Bulletin No.: 14888B
Date: June 2015

PRODUCT SAFETY RECALL

SUBJECT: Front-Brake Caliper Leak

MODELS: 2015 Chevrolet Colorado
2015 GMC Canyon
With Less Than 3,000 Miles (4,800 km)

Front Caliper Body Casting: Outboard Body

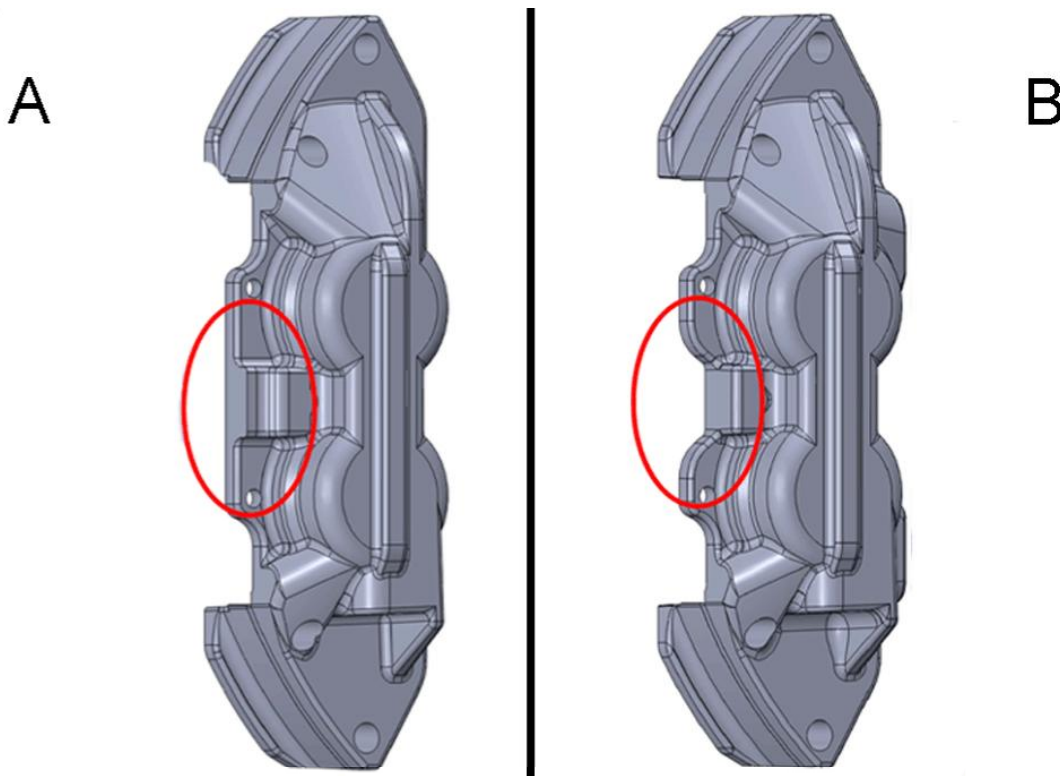
(A) Original Design Front Caliper Body Casting (B) New Design Front Caliper Body Casting. The shape of the pin ledge is different between the two designs. Refer to the area in the circles of the illustration to review the differences in the shape of the pin ledge from the original design to the new design.

3. Perform a visual inspection of the front calipers to determine the body casting design of the caliper.
 - If the vehicle is equipped with the original design front caliper body casting, remove and replace both front calipers. Proceed to step 4.
 - If the vehicle is equipped with the new design front caliper body casting, no further action is required. Install the tire and wheel assembly and lower the vehicle. Refer to *Tire and Wheel Removal and Installation* and *Lifting and Jacking the Vehicle* in SI.
 4. Remove the front brake calipers from the vehicle. Refer to *Front Brake Caliper Replacement* in SI.
- Note:** Transfer the brake pads from the old calipers to the new calipers BEFORE discarding the brake calipers.
5. Discard the front brake calipers.
 6. Install new front brake calipers to the vehicle. Refer to *Front Brake Caliper Replacement* in SI.
